Project	IEEE 802.16 Broadband Wireless Access Working Group < http://ieee802.org/16 >	
Title	Clarification on STC Data Mapping for Optional Zones	
Date Submitted	2005-03-09	
Source(s)	<p>Wonil Roh, JeongTae Oh, Kyunbyoung Ko, Chan-Byoung Chae, Hongsil Jeong, Sung-Ryul Yun, Seungjoo Maeng, Jaeho Jeon, Jaeyeol Kim, Jaehee Cho, Soonyoung Yoon, Yong Chang</p> <p>Samsung Electronics Co., Ltd.</p> <p>David Garrett, Erik Lindskog, Kamlesh Rath, Aditya Agrawal</p> <p>Beceem Communications, Inc.</p>	<p>wonil.roh@samsung.com</p> <p>Voice: +82-31-279-3868</p> <p>dgarrett@beceem.com</p>
Re:		
Abstract	Clarification on STC data mapping for Optional Zones	
Purpose	Adoption of proposed changes into P802.16e	
Notice	<p>Crossed-out indicates deleted text, underlined blue indicates new text change to the Standard</p> <p>This document has been prepared to assist IEEE 802.16. It is offered as a basis for discussion and is not binding on the contributing individual(s) or organization(s). The material in this document is subject to change in form and content after further study. The contributor(s) reserve(s) the right to add, amend or withdraw material contained herein.</p>

Clarification on STC Data Ma

Figure 251k – Burst Packing of Two Vertically Encoded Streams with CTC H-ARQ

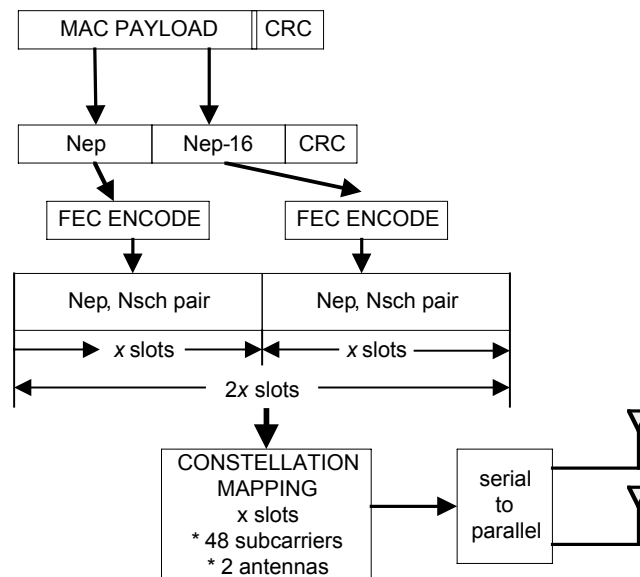
For multiple spatial rate transmission and H-ARQ CTC, the packet shall be formed by concatenating multiple Nep/Nsch FEC codewords together. For the case of vertical encoding (number of layers=1), there shall be only 1 CRC check at the end of the last codeword. For the case of horizontal encoding (number of layers >1), each burst shall be a separate Nep/Nsch pair with separate CRC. The randomization seed shall be reset for all of the Nep/Nsch pairs in the combined codeword. Figure 251k shows an example of vertically encoded rate 2 with CTC H-ARQ transmission.

Figure 2511 — Uplink data mapping for 2-antenna SS with matrix A for the optional PUSC permutation

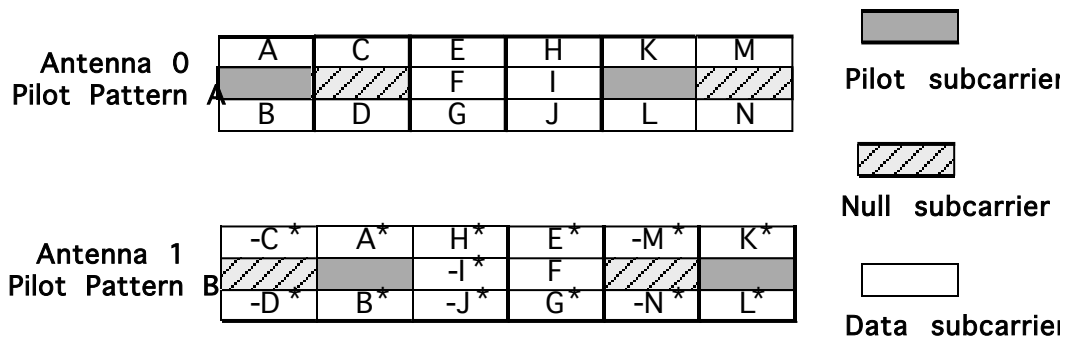
For the optional PUSC permutation with transmit diversity (TD), the data subchannels shall be allocated for two consecutive slots in time. As can be seen in Figure 2511, STC encoded data symbols shall be time mapped over two OFDMA symbols. The mapping starts at the lowest numbered subcarriers of lowest slot and continues in an ascending manner in subchannels first and then proceeds to the next two symbols in time.

For 2-antenna matrix B (SM) in the optional PUSC permutation, modulated data symbols shall be sequentially mapped for two transmit antennas along the subcarriers in the symbol. The mapping continues in an ascending manner in subchannels first and then proceeds to the next symbol in time.
